A7. POST-APPLICATION DISCUSSION

COMMENTS BY THE PRIMROSE HILL CONSERVATION AREA ADVISORY COMMITTEE

Primrose Hill Primary School Princess Road NW1 8JL Listed Building PRE-APP

A7.2.1 10.05.16. Robert Loader and David Walter met Tanya Skelli-Yaoz and Sarah Freeman at LB Camden to present the proposals. The points arising from the meeting are set out below.

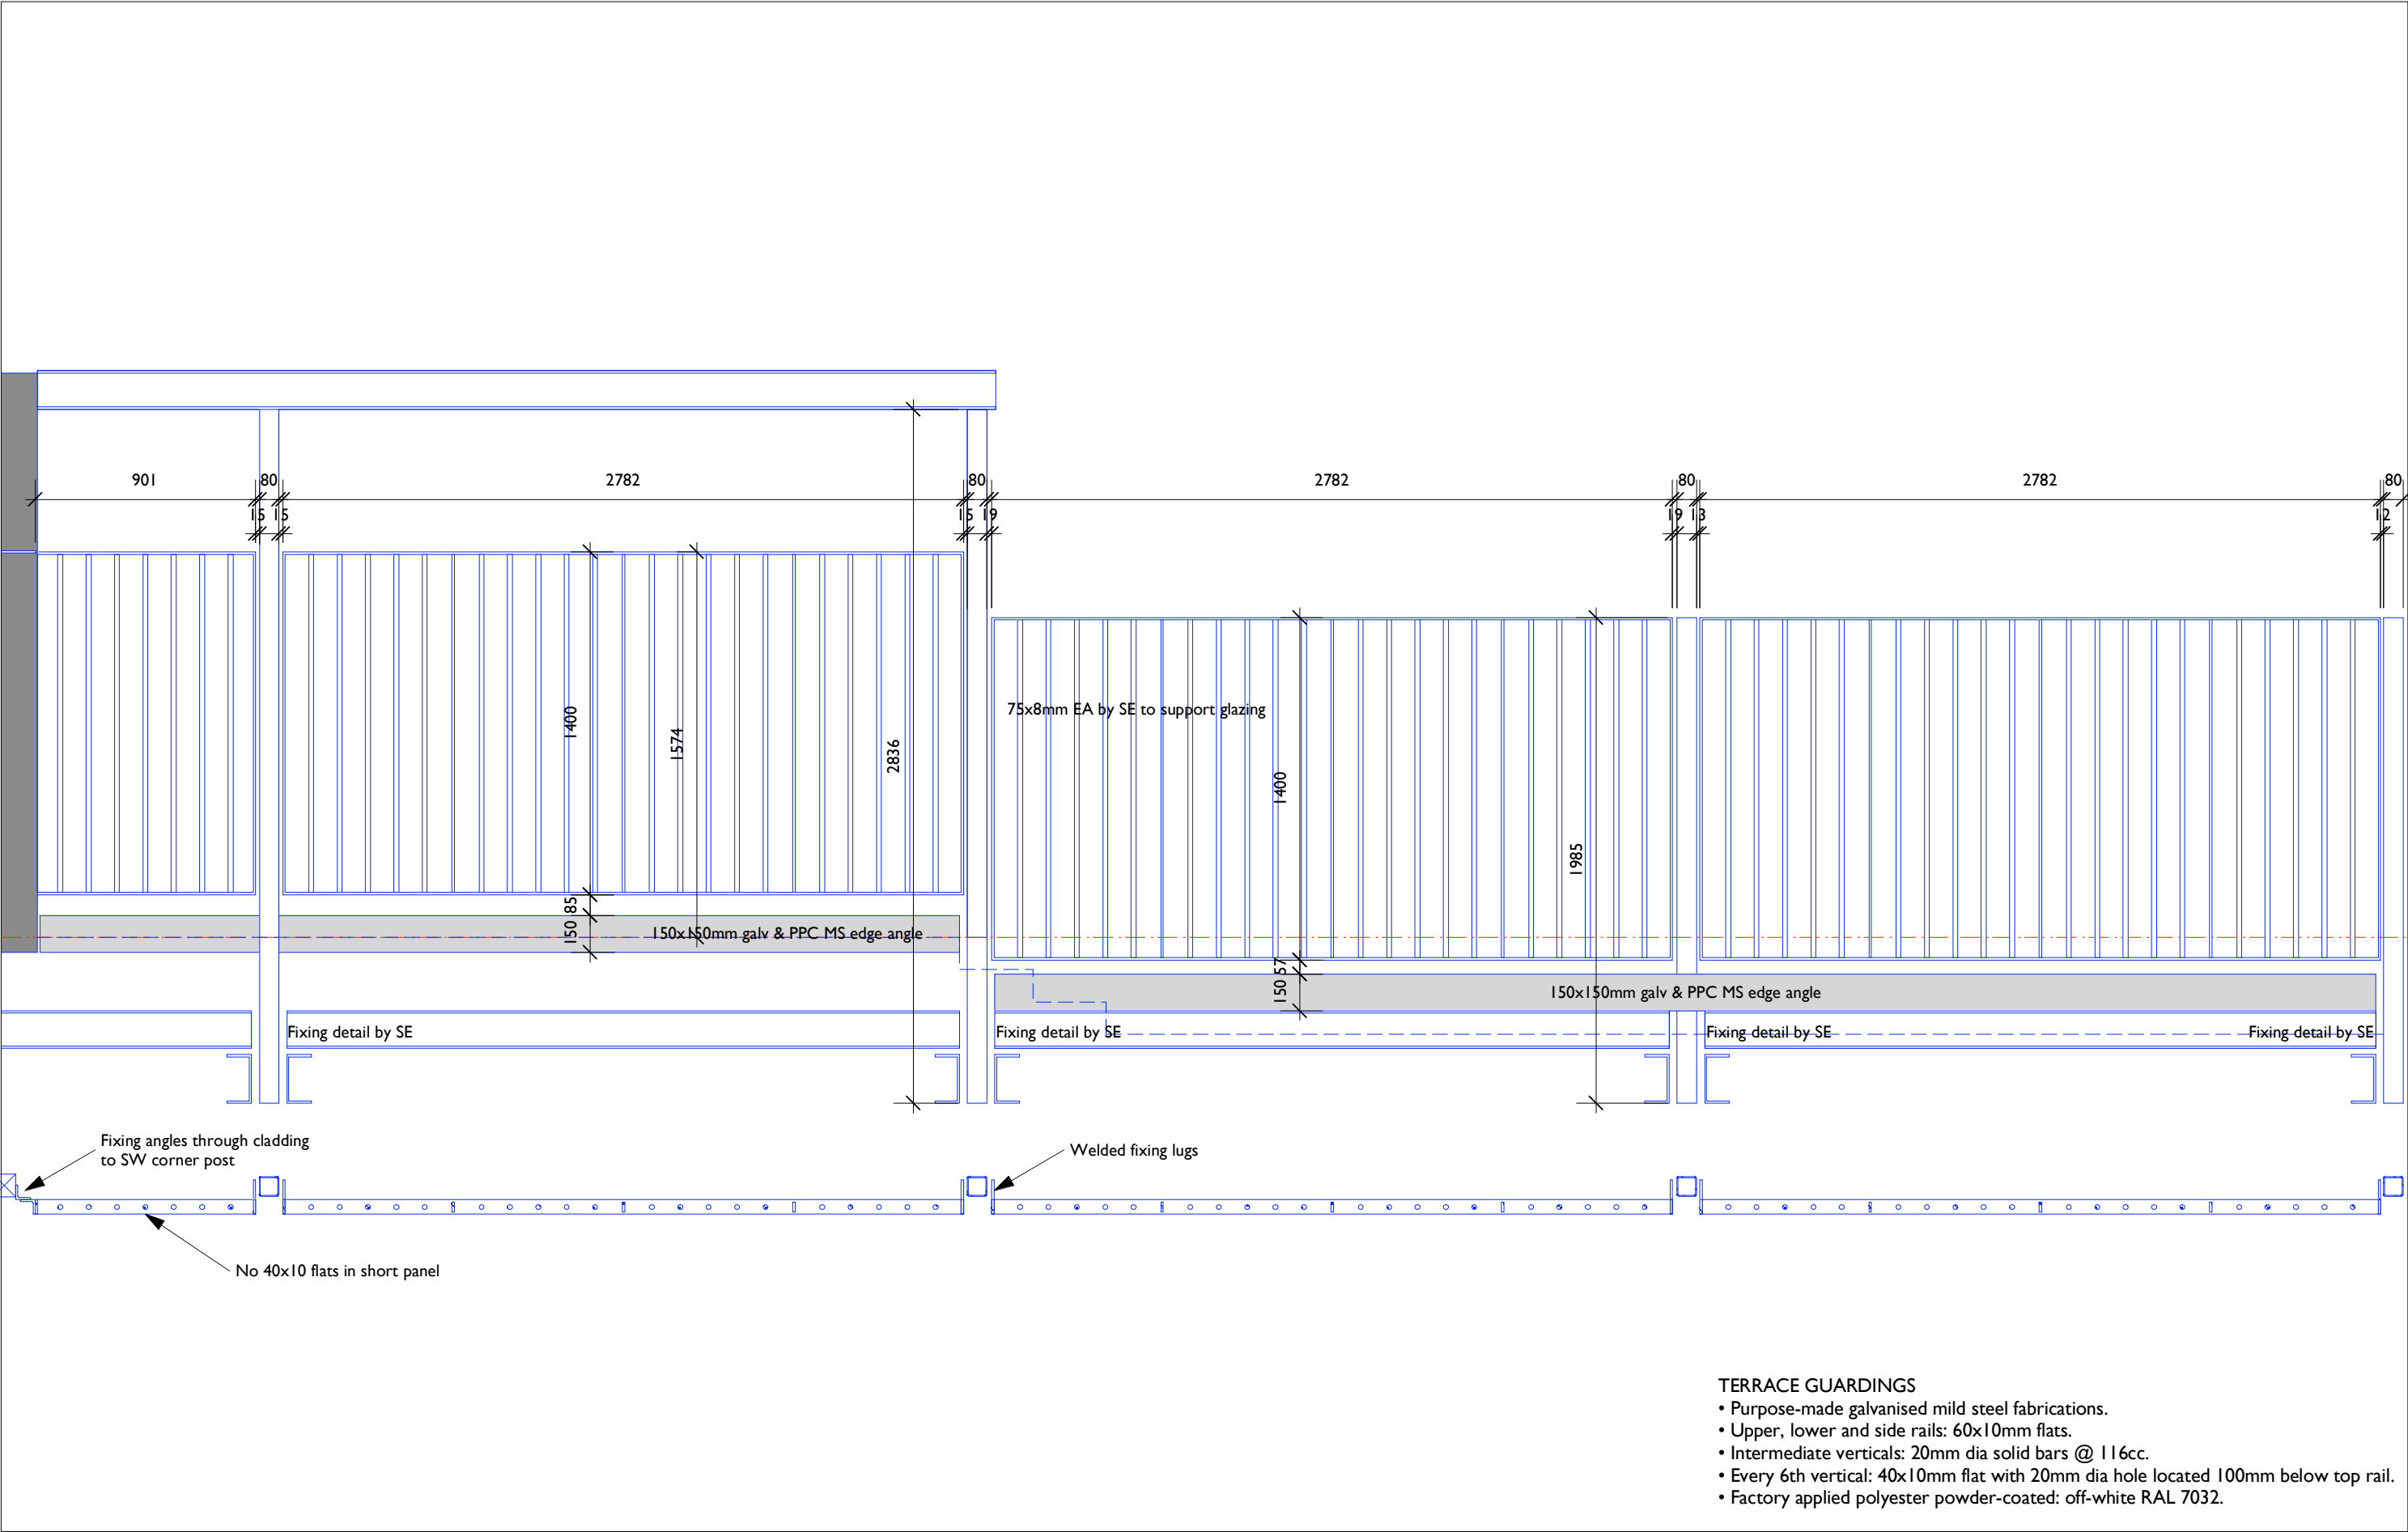
17. 1:10 Details of guarding around 2YO terrace to be provided. More 'open' design to be considered than 60x10 uprights so visibility isn't lost so quickly when viewed obliquely.

Response: Further details at 1:10 of the guarding around the 2YO terrace are provided. Guarding uprights have been revised to be predominantly circular bars to provide better oblique visibility. Every sixth upright is a flat, and this sub-division of panels will give a visual rhythm to the outside view of the terrace.

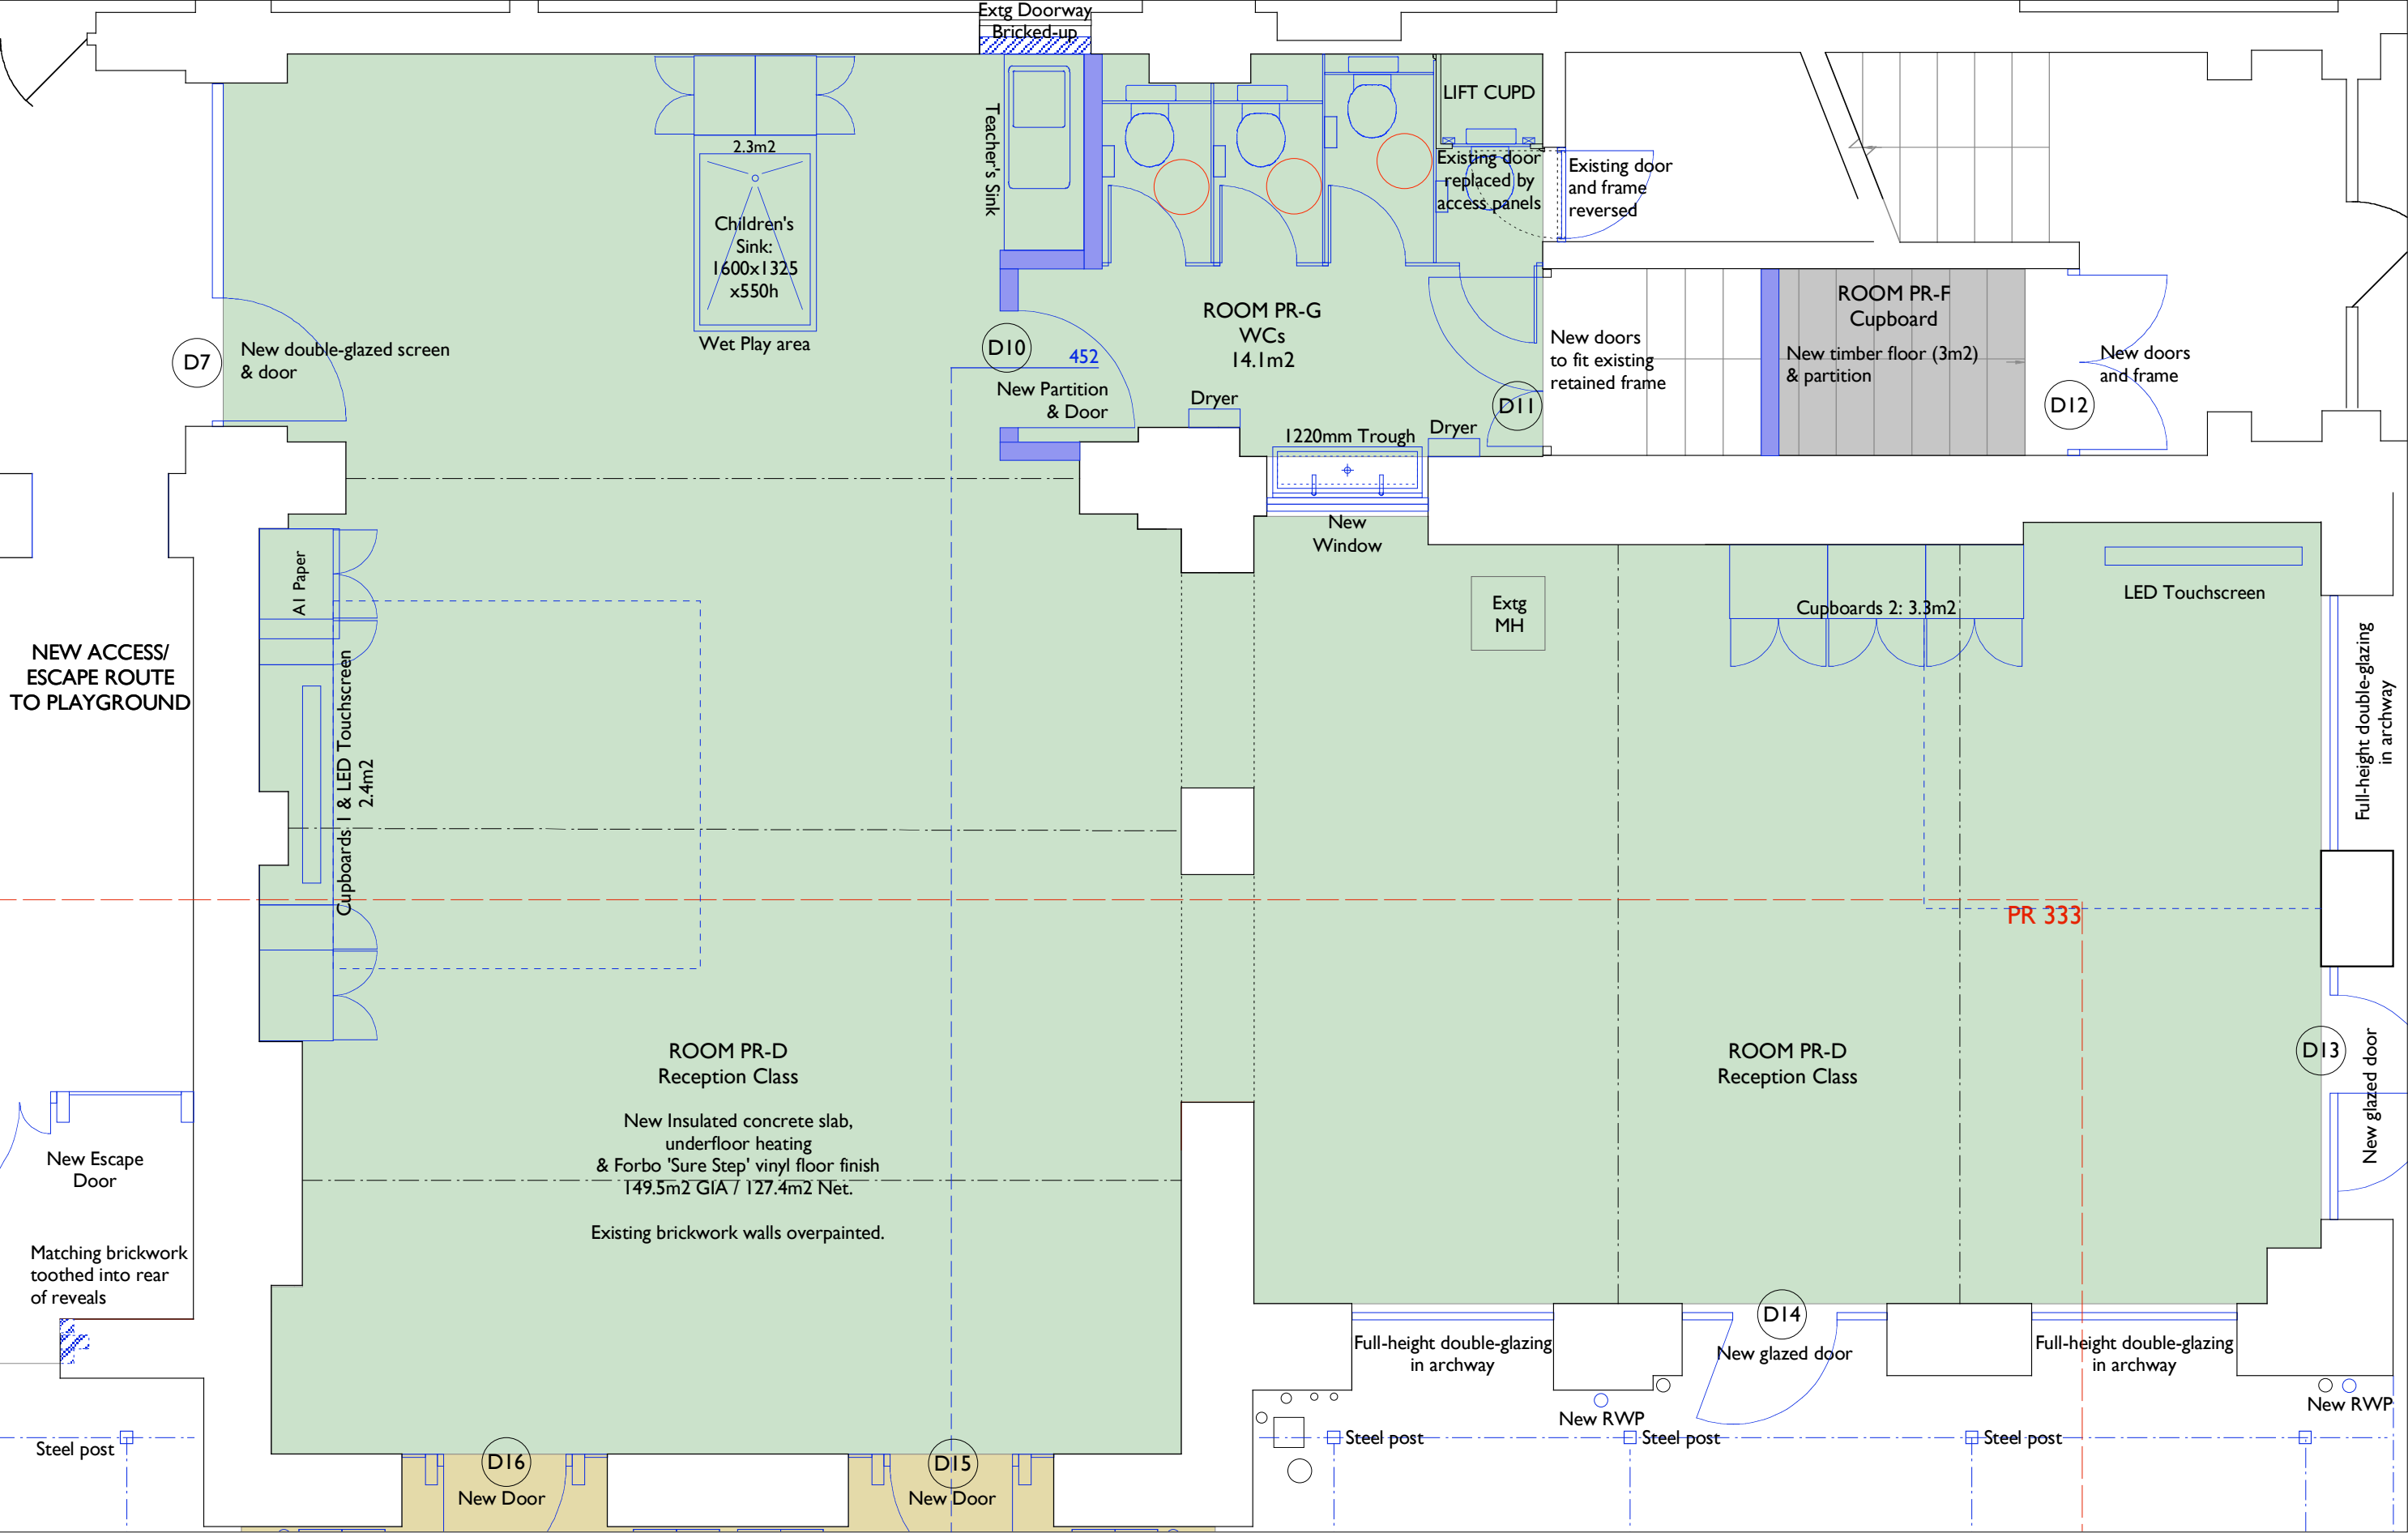
5. LBC will resist removal of the original lift housing/ current cupboard in Reception WCs. RL to assess effect of floor area loss if WCs are moved to side.

Response: Revised proposals are attached below showing the original lift cupboard to be retained with the non-original door replaced by access panels and a new WC to be located in front. The adjacent door and frame to the cupboard under the stairs is reversed. Drawings attached below: PRPS PR 332_G and PRPS PR 512_G.
